▶ **FILE #:** 7-A-10-UR

▶ **PROPOSED USE:** Parking lot

▶ **APPROVE** the revised development plan to permit the construction of up to 75 additional parking spaces as shown on the plan subject to 10 conditions

THE VILLAGE AT HARDIN VALLEY
 SPRING BLUFF WAY
 KNOXVILLE, TENNESSEE

SITE PLAN
SCALE: 1" = 40'-0"

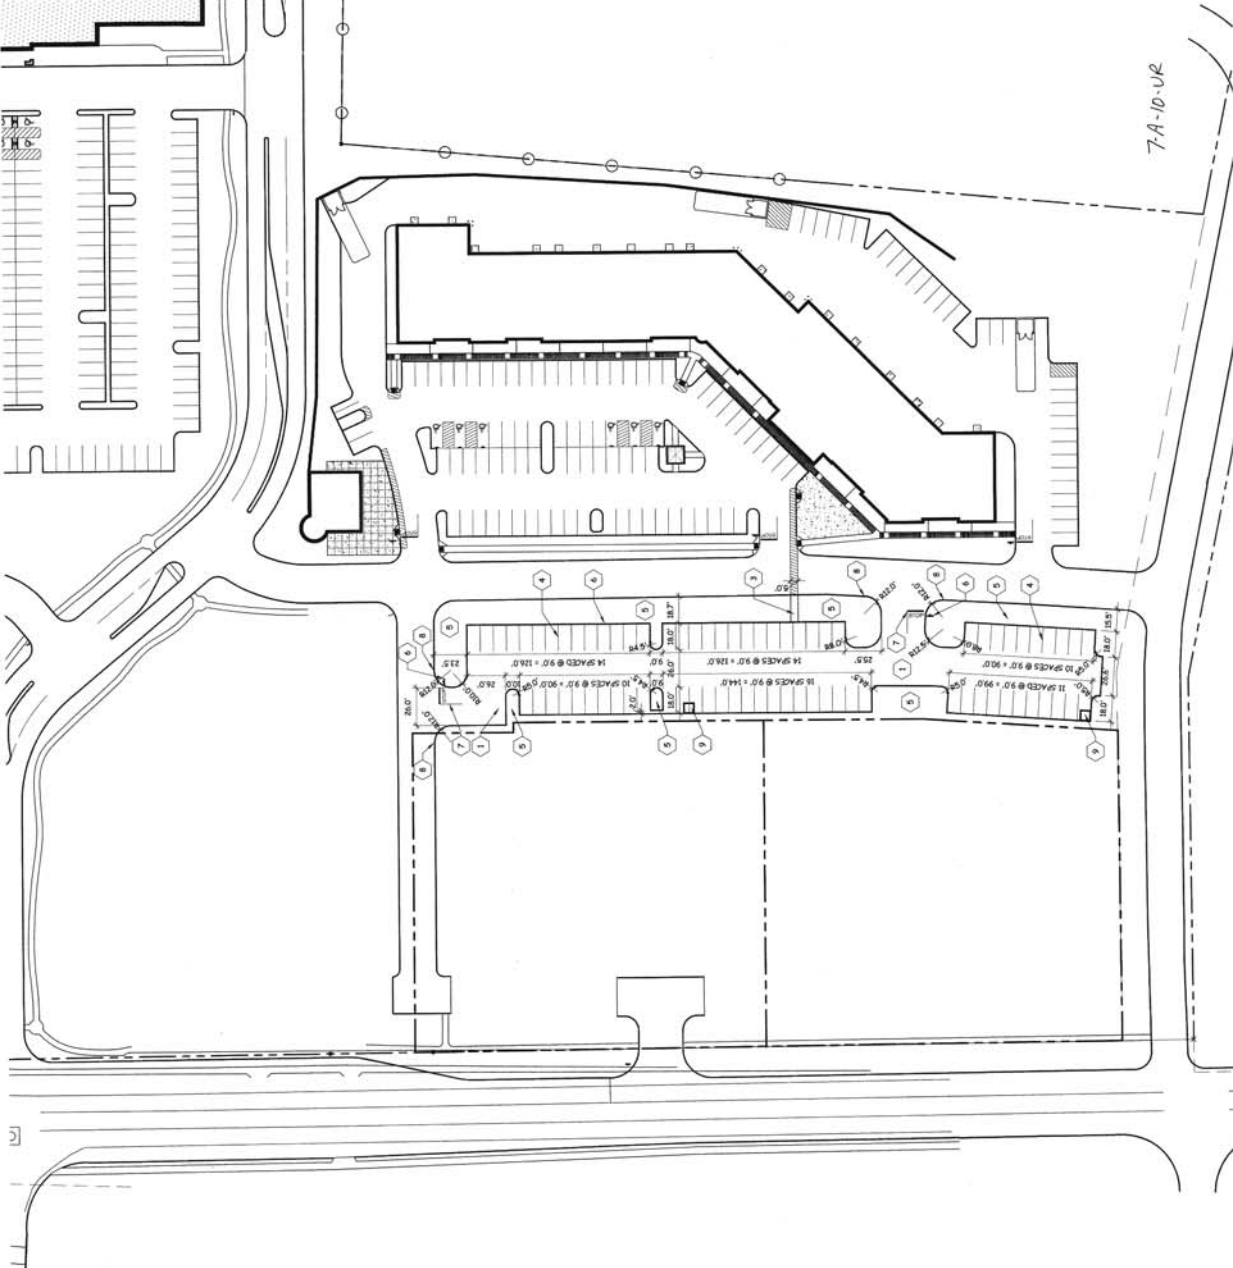
The original development plan for the out parcels provided for limited access to Hardin Valley Rd. with additional access from the rear of the lots from Spring Bluff Wy. The proposed parking lot cuts off the rear access to those lots. Staff will continue to recommend access to Hardin Valley Rd. be limited, therefore the rear access to the out parcels must be restored in some form.

5. Provision of access to the rear of the out parcels from Spring Bluff Wy.
6. Replatting the out parcels via the appropriate subdivision process
7. A separate use on review request will be required for each out parcel

10. A revised site plan reflecting the conditions of approval must be submitted to MPC staff for review and approval prior to commencing any grading on this site
